STATE OF NORTH CAROLINA
DEPARTMENT OF TRANSPORTATION

SUBJECT: NCDOT Response to the § 401 Water Quality Certification Application- Request for more information. The widening of Brawley School Road and New Interchange with I-77 from SR 1109 to east of I-77 in Iredell County. TIP No. R-3833B.

REFERENCE: June 11, 2008 401 Certification Application
July 30, 2008 401 On- hold letter
Attached:
EEP Letter for Additional Mitigation Requested
Catawba Buffer Treatment Tables
Revised Permit Drawings Sheets 5 and 6 of 23
Revised Buffer Drawings Sheets 6-9 of 11
Revised Roadway Drawings Sheet 8
Revised Pre-Construction Notification

Permit Drawing Replacement
 Sheet 5 of 23

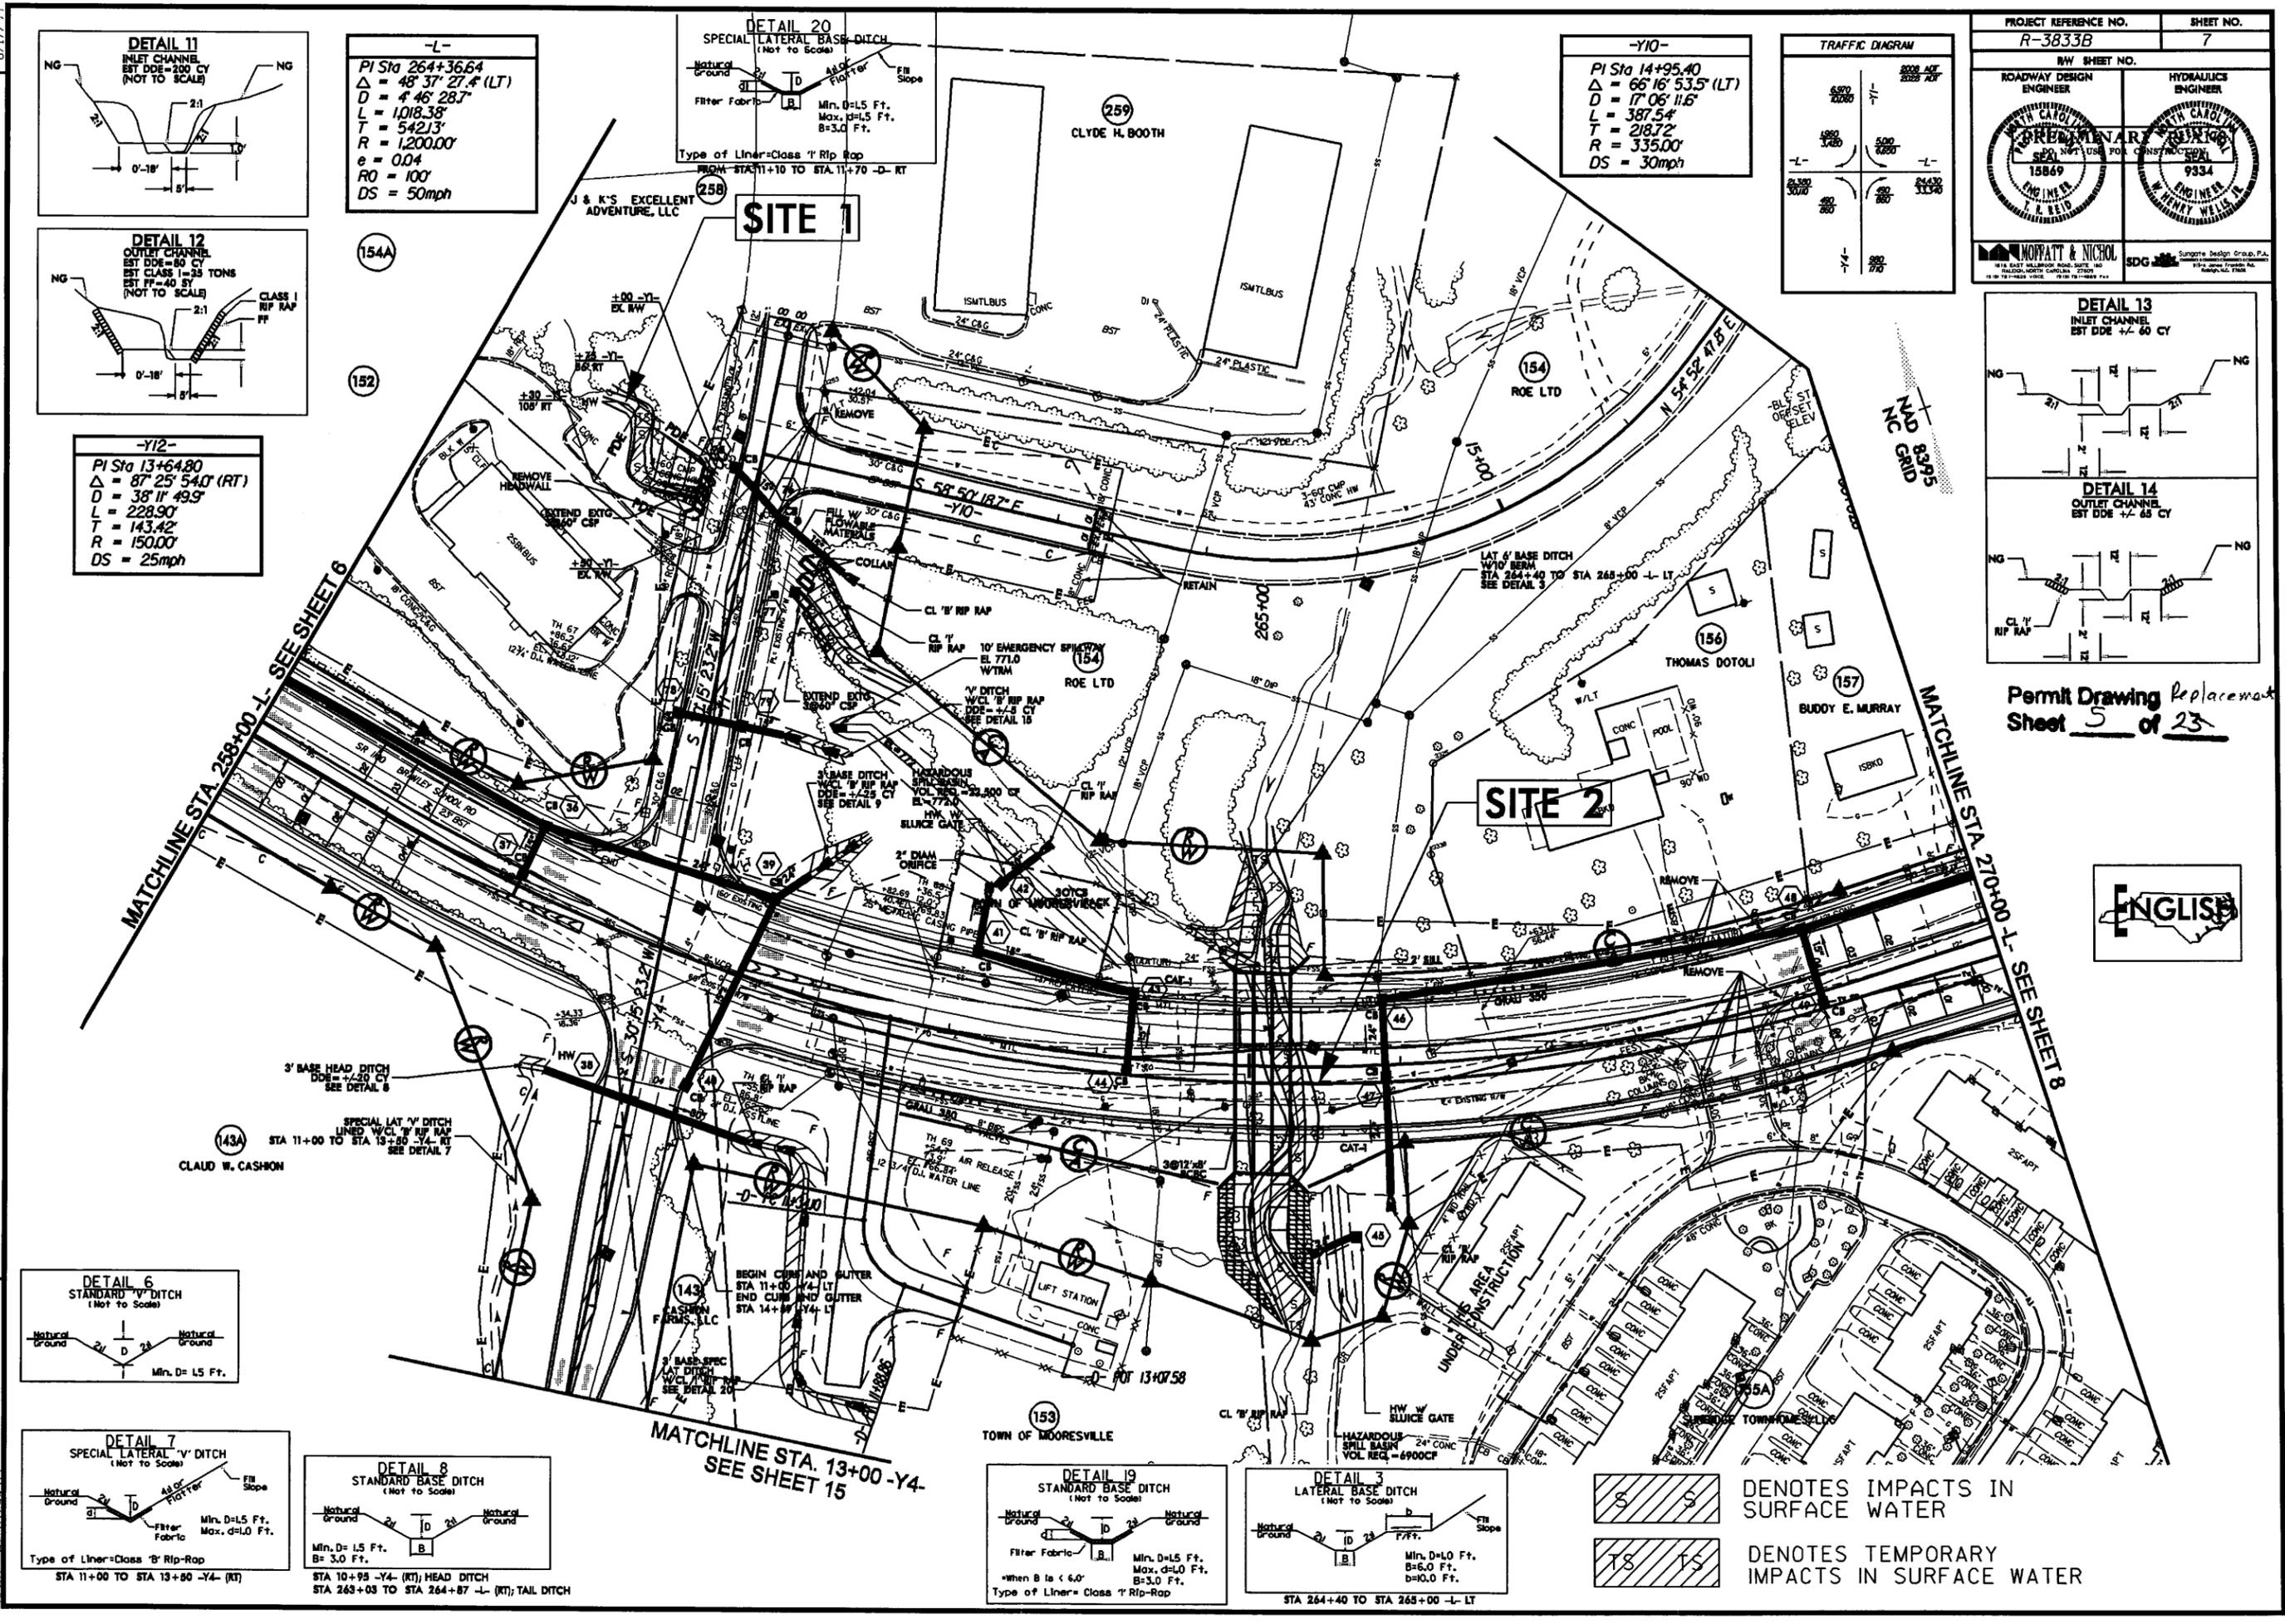
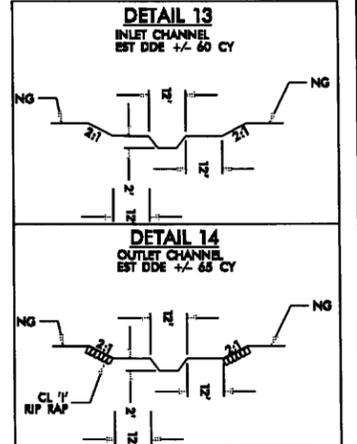
“Please provide a detail or additional information on how the unnamed tributary (UT) at Site 2 will be tied into the proposed ditch and the type of ditch proposed.”

A replacement Permit Drawing Sheet 5 of 23 is attached to this letter. The new sheets display proper alignment with the channel. No changes in impacts result from this drawing adjustment. The relocated channel will be a grassed 6' base ditch. The proposed channel improves the existing cross section as the existing slide slopes will be flattened (the existing banks are nearly vertical).

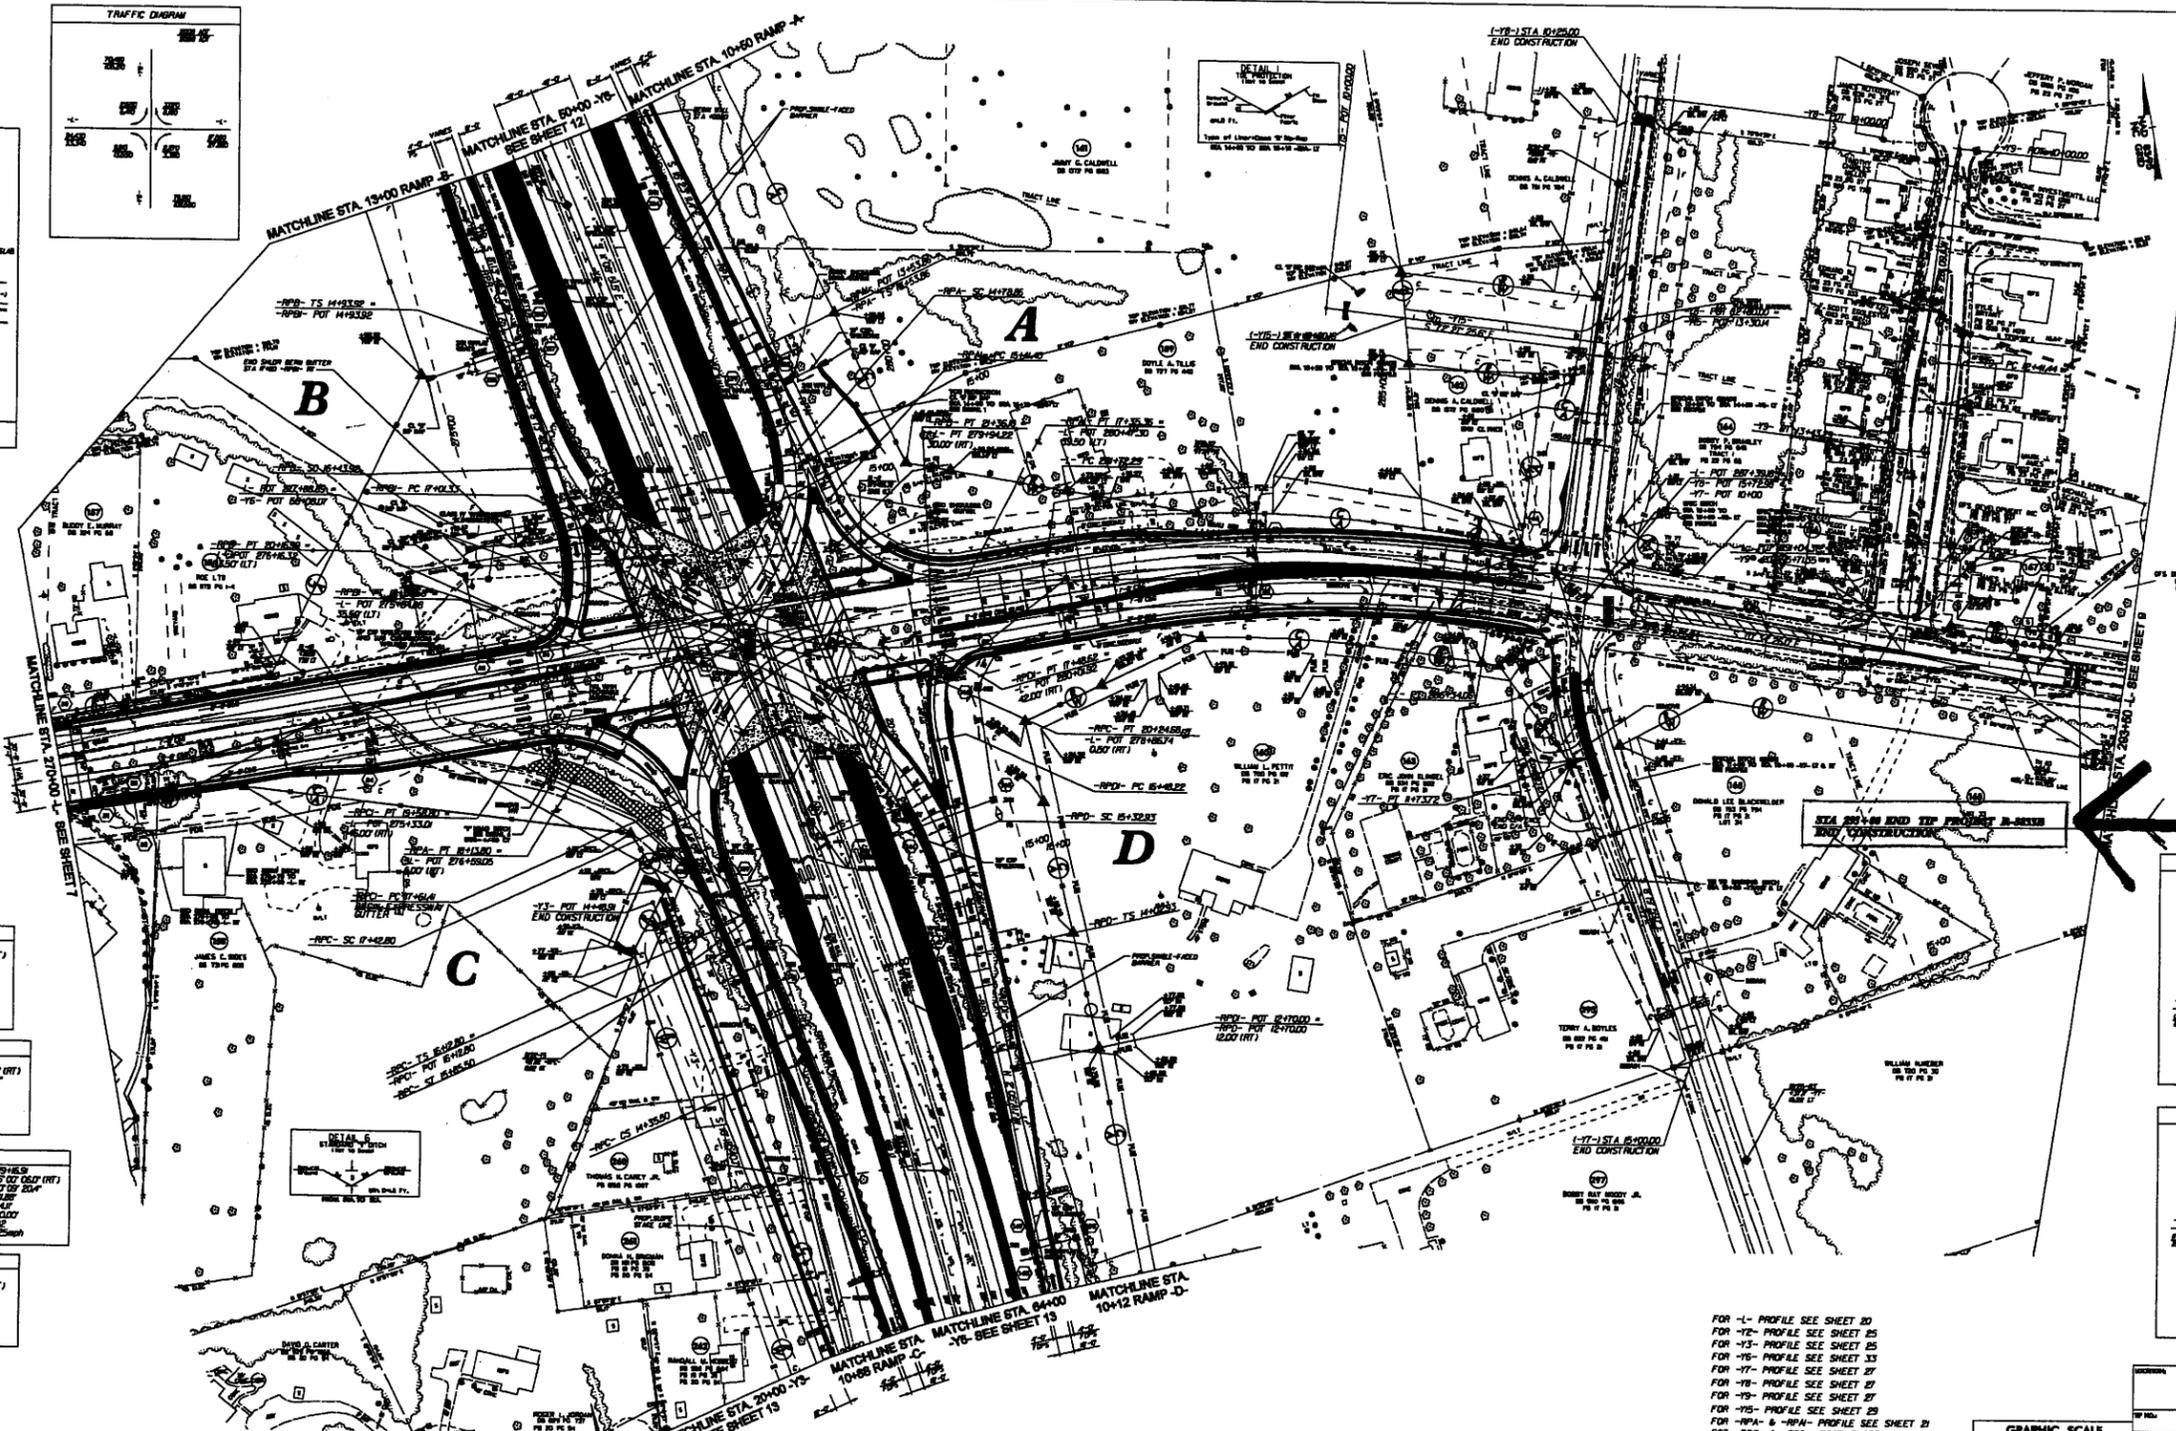
“Based on discussions, it is our understanding the impacts to Permit Site 7 will be avoided. If impacts will be avoided, please provide revised plans and the appropriate PCN sheets. If impacts cannot be avoided, please revise the impact summary table.”

Due to the shortening of the project, Permit Site 7 will no longer be impacted for this project. NCDOT has included in this response a revised PCN and plan sheets to show the project’s termination before the previous “Site 7”. This reduction will reduce project impacts by 90 linear feet.
